ADDENDUM NO. 1  
SEWERAGE SYSTEM IMPROVEMENTS  
CONTRACT 16-01  
PEAK WASTEWATER FLOW DIVERSION  
PUMPING STATION MODIFICATIONS  
CLEVELAND UTILITIES  
CLEVELAND, TENNESSEE  
CU PROJECT NO. S2683X  
WAUFORD PROJECT NO. 4626

Date of Addendum: Wednesday, April 5, 2017

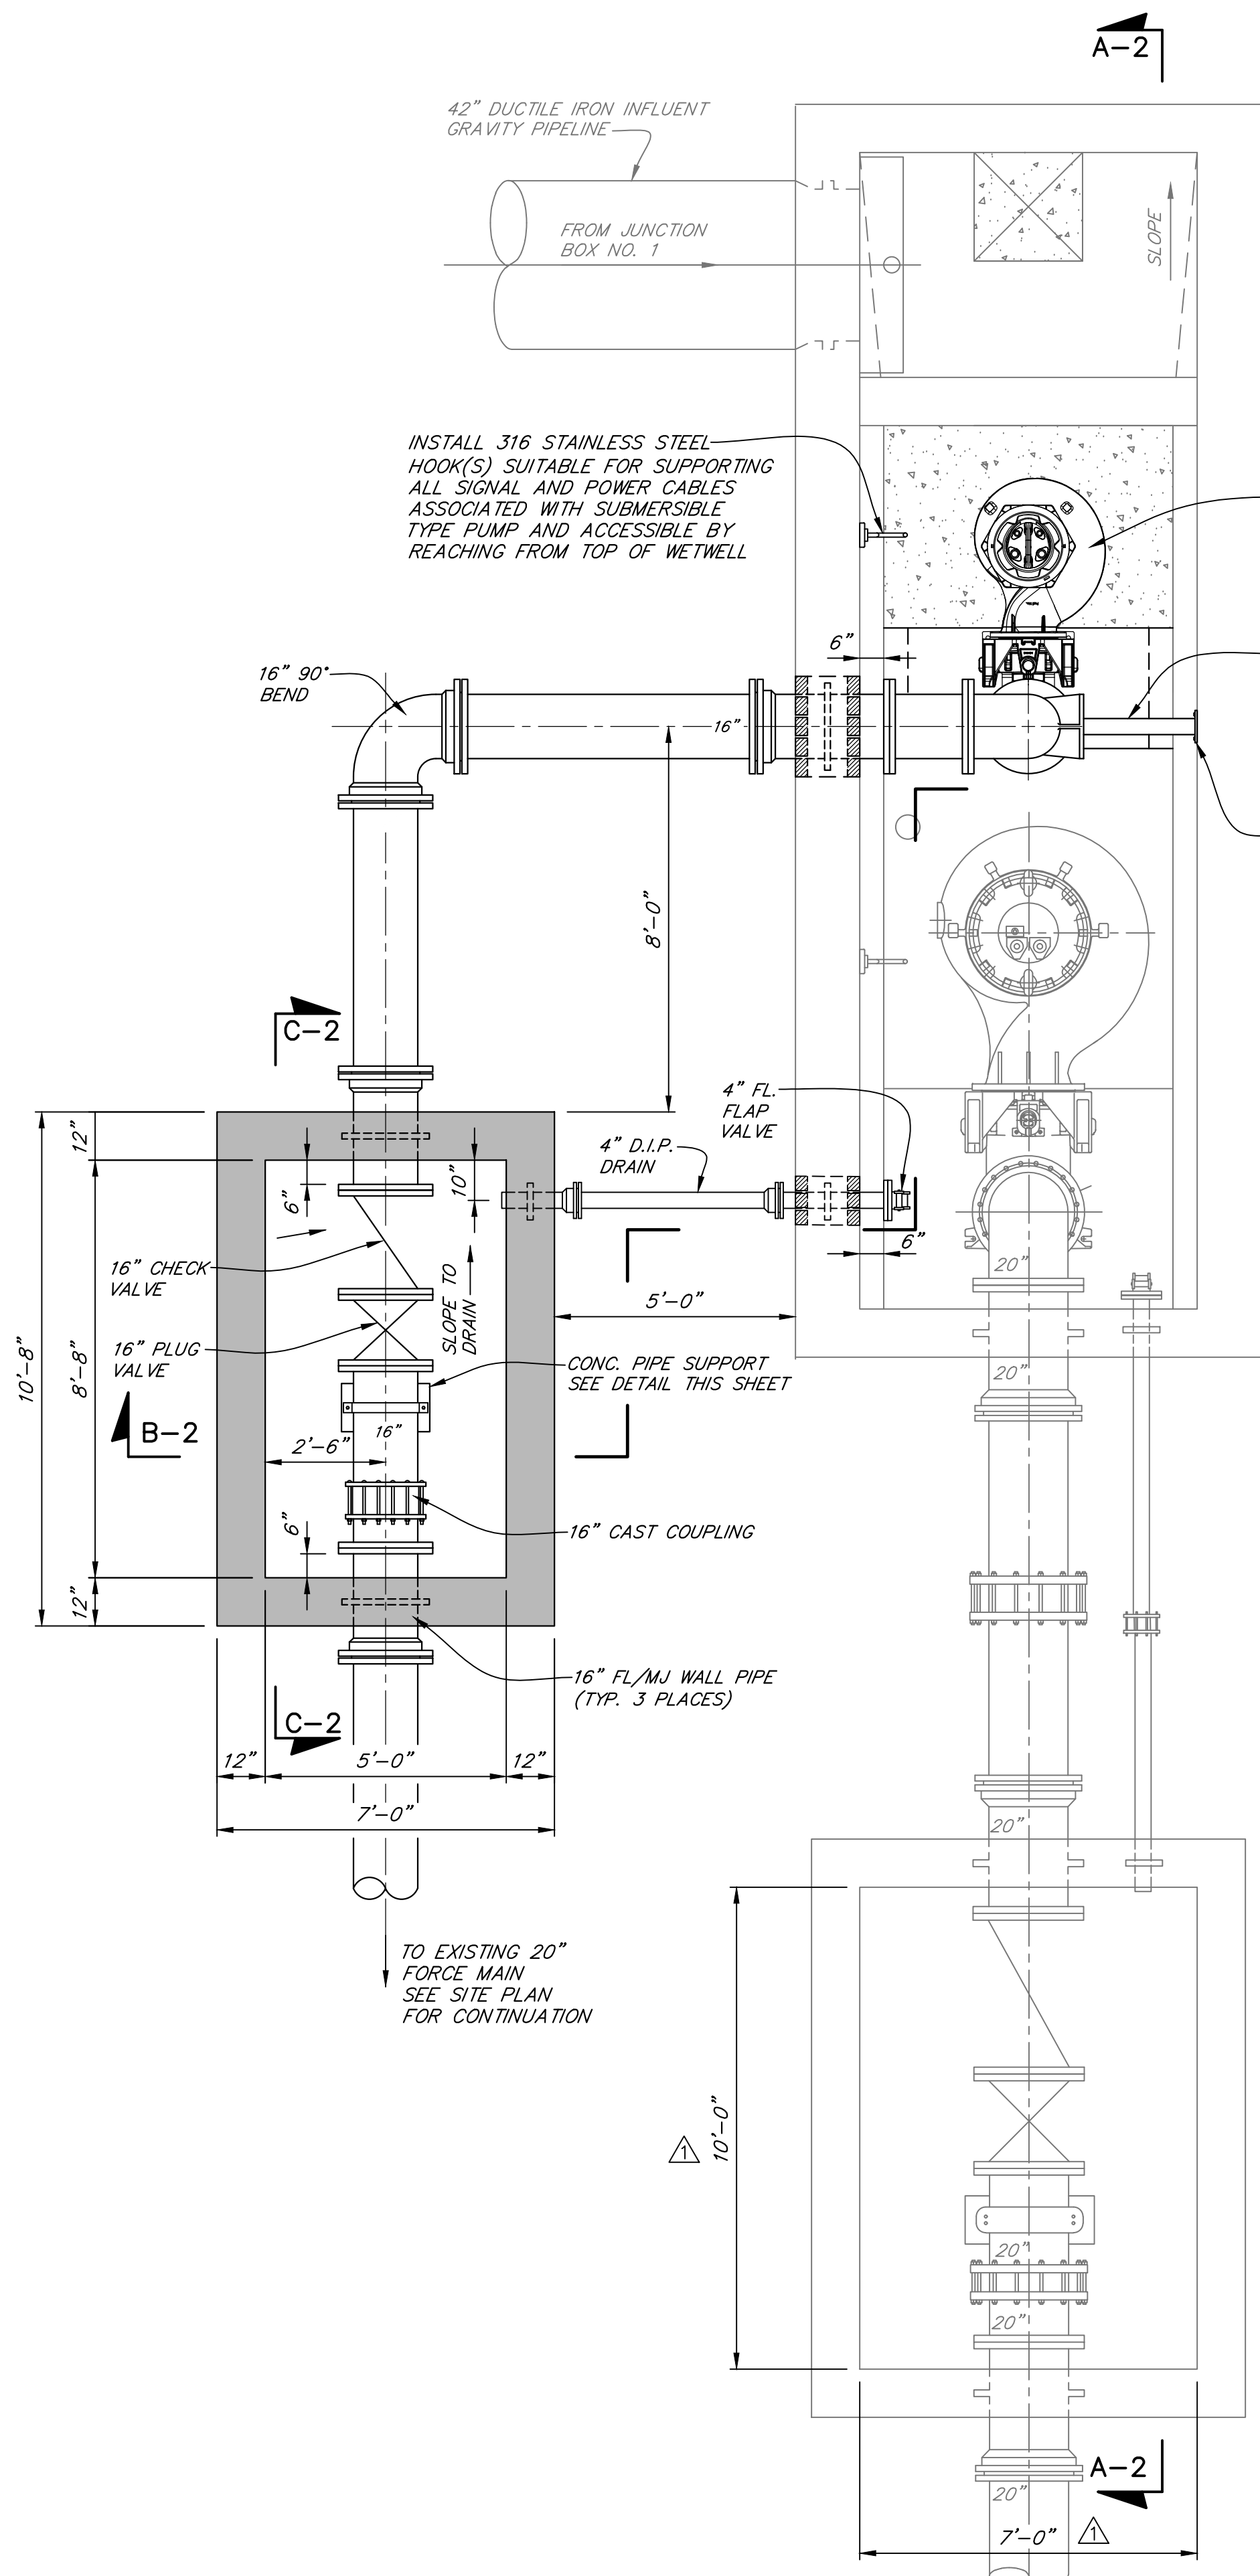
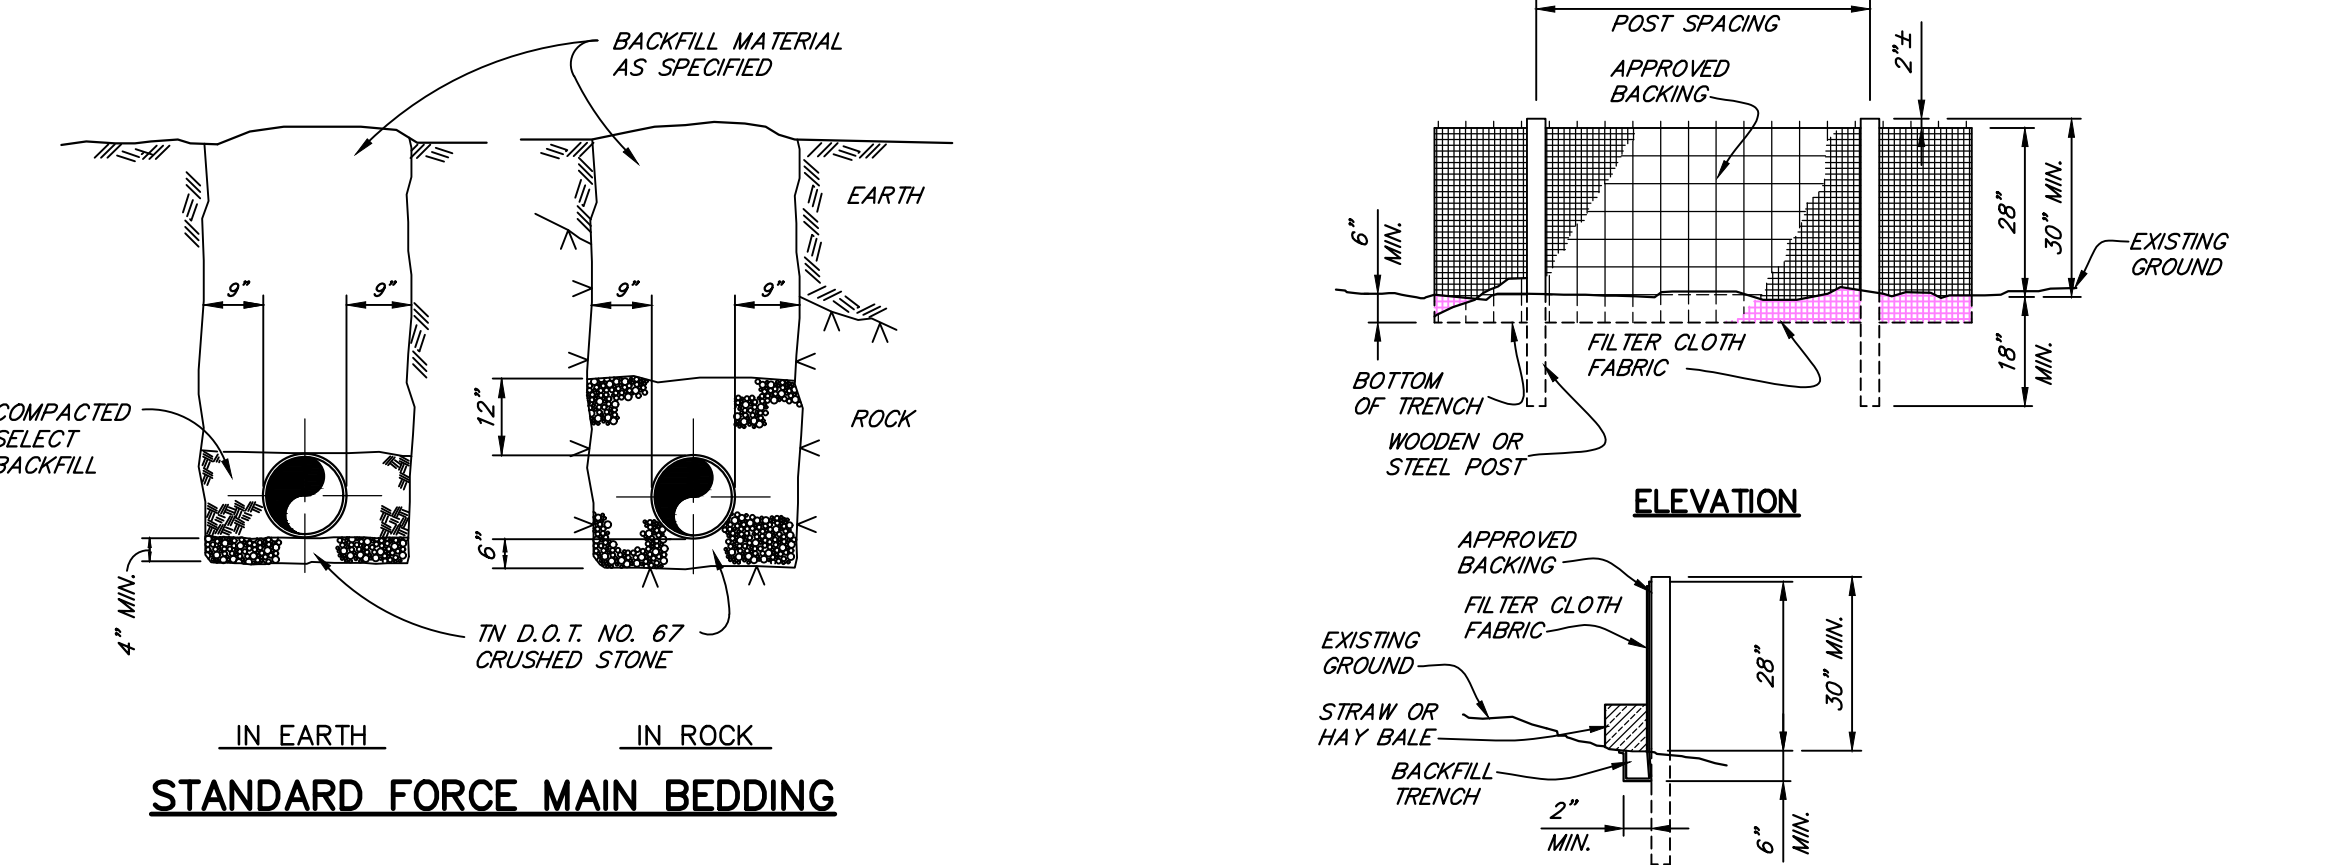
6. Plans, Sheet 1:  
Revise as shown on attached Plans, Sheet 1.
7. Plans, Sheet 2:  
Revise as shown on attached Plans, Sheet 2.
8. Plans, Sheet 3:  
Revise as shown on attached Plans, Sheet 3.
